# **PRODUCT ADVISORY**

**Data Sheet Specification  
Change for Intersil Products  
ISL97682\*, ISL97683\*, and  
ISL97684\***

**Refer to:  
PA12037**

**Date: May 17, 2012**

FIGURE 1. ISL97684 TYPICAL APPLICATION DIAGRAMS

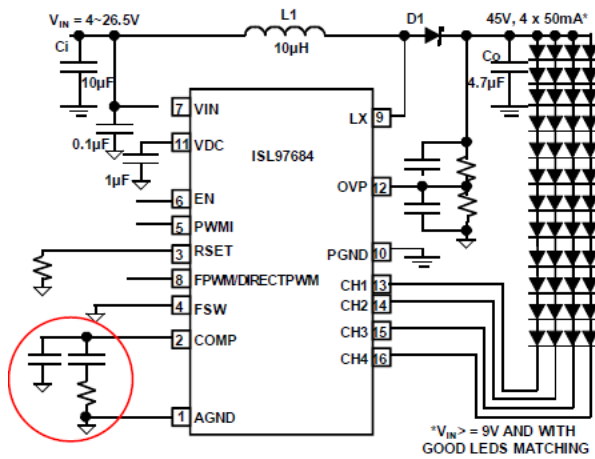
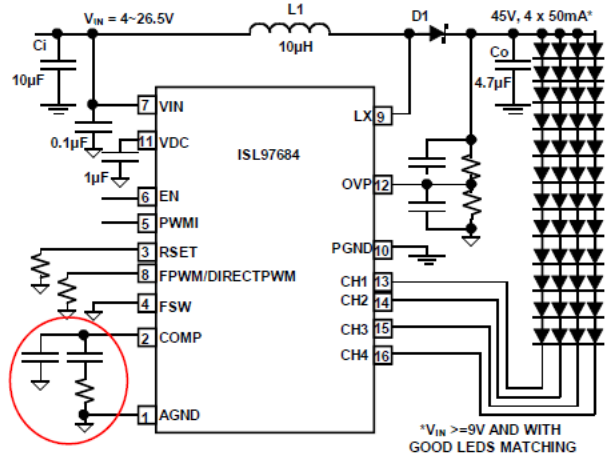
This advisory is to inform you that Intersil has changed the data sheet specification for the listed ISL97682\*, ISL97683\*, and ISL97684\* products. The updates specify the resistor and capacitor values for the COMP pin in the *Figure 1 - Typical Application Diagrams* and change the FSW (Switching Frequency) voltage levels in the *Pin Descriptions* table and *Switching Frequency and PWM/PFM Mode* section of the data sheet. Details regarding the changes are contained on the following pages. The updated data sheet is available on the Intersil web site at <http://www.intersil.com/content/dam/Intersil/documents/fn76/fn7689.pdf>.

- Figure 1 - Typical Application Diagrams (Page 1):

Change From:

FIGURE 1. ISL97684 TYPICAL APPLICATION DIAGRAMS

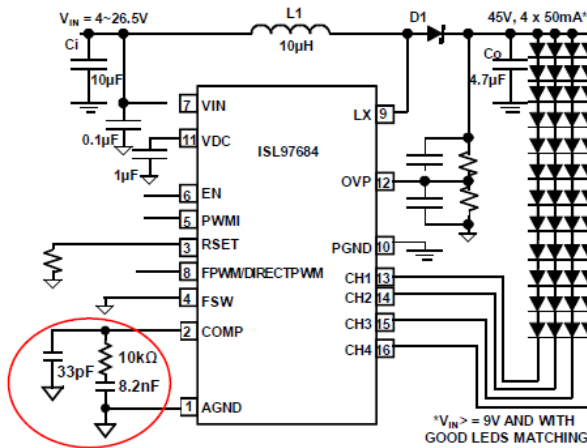
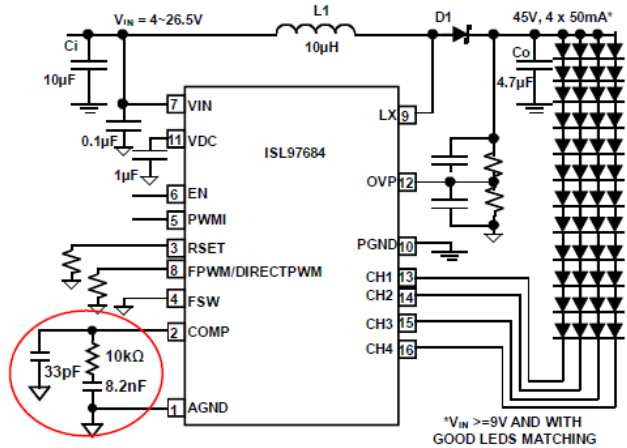
Change To:
